The following amendments to drawings and specifications shall be incorporated into, and forms part of, the contract.

END OF ADDENDUM NO. 6

PROJECT: INGONISH CIVIC BUILDING
 SUBJECT: GRILLE DIFFSUER DESIGNATIONS
 DATE: 15 AUG 2014

APPROVED: APPROUVÉ: PAR:	PG	<i>P.D.</i>
SCALE: ÉCHELLE:	N.T.S.	
DRAWING NO.: NUMÉRO DU DESSIN:	MSK-413-02

REFERENCE DRAWING: DOOR SCHEDULE ELEVATION SHEET 360

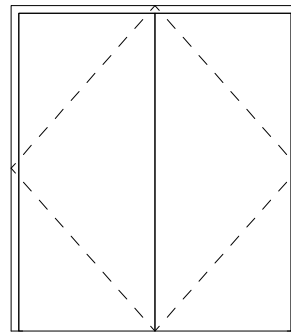
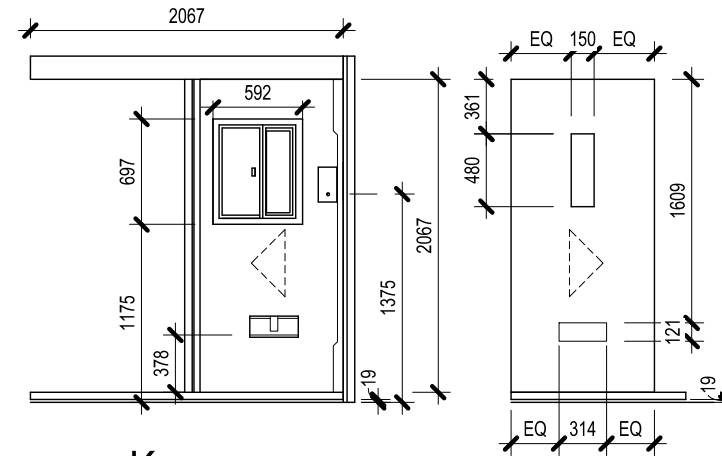
- b. 111A, Door Type - Revise to read "HM"
- c. Revisions to Door Elevations per ASK 30

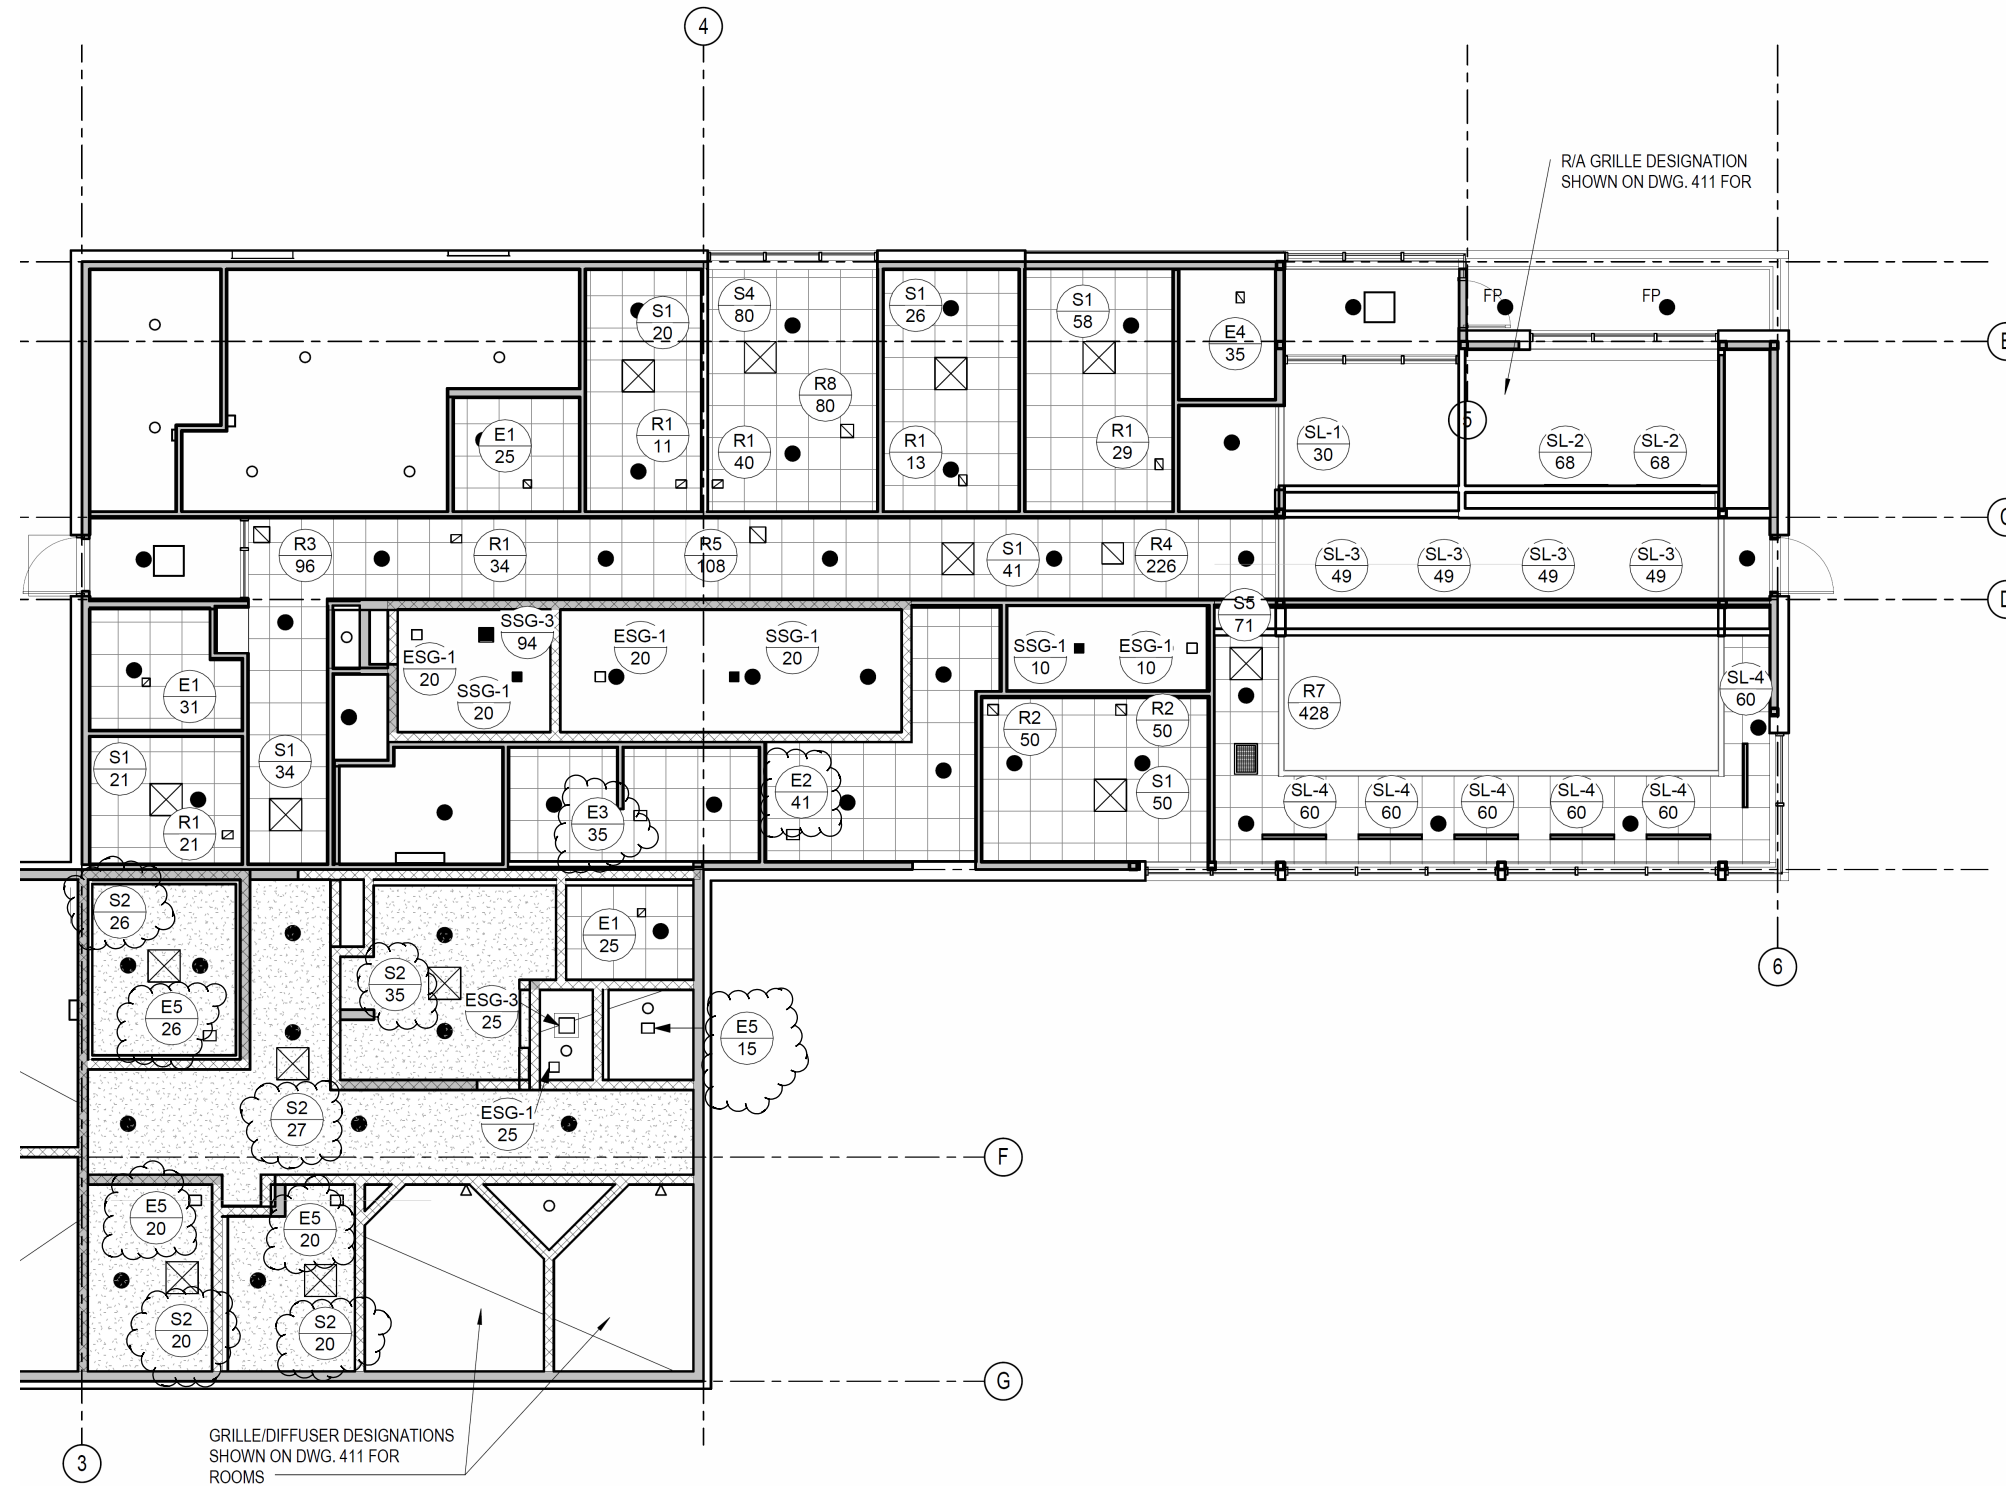
- 1. Revisions to diffuser grill designations per attached MSK-413-02
